DESIGN REVIEW BOARD (DRB)

Meeting Minutes
December 19, 2024
7:00 PM

- A. Review Acton 250 Committee Projects

1) Informational Signs:

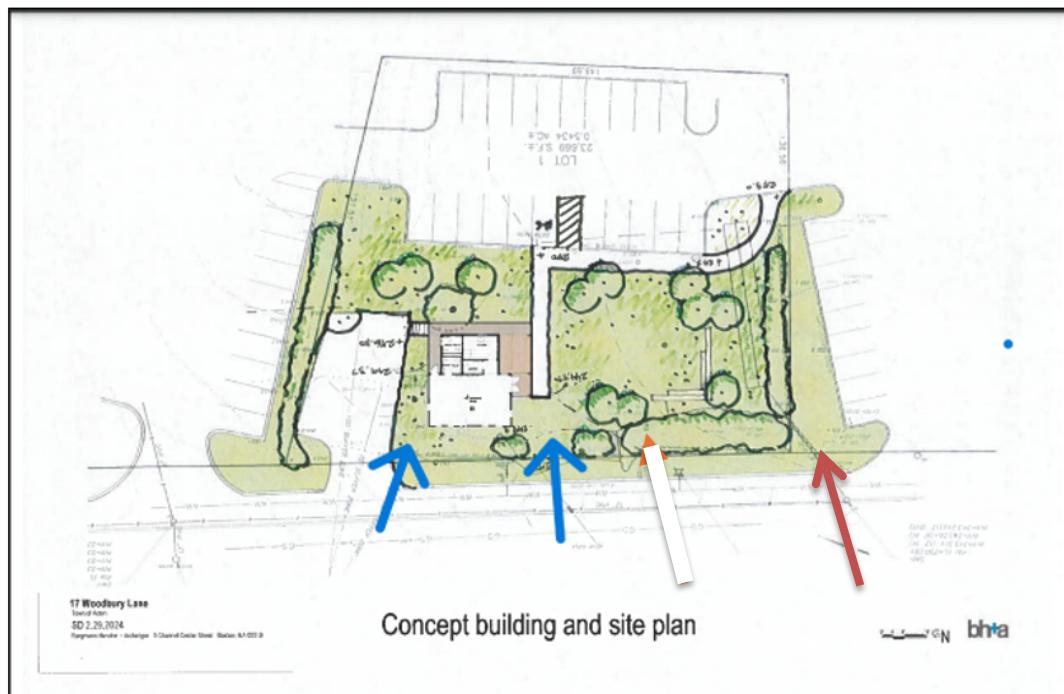
- This would include the large information signs (Type 1) proposed at:
 - a) Horse trough across 27 from Town Hall (or Fire Station).
 - b) Post Office / Rte. 27 intersection Line of March (LOM) #7 of Conant Property.
 - c) BFRT side of Conant acquired property.
 - d) Asa Parlin House Left side near LOM Marker #5.
- As well as the (LOM) smaller signs (Type 2) in Acton.
- Inground installation looks nicer but perhaps needs some pavers or something.
- Will the steel posts last? Should be hot-dip galvanized or stainless steel or aluminum.
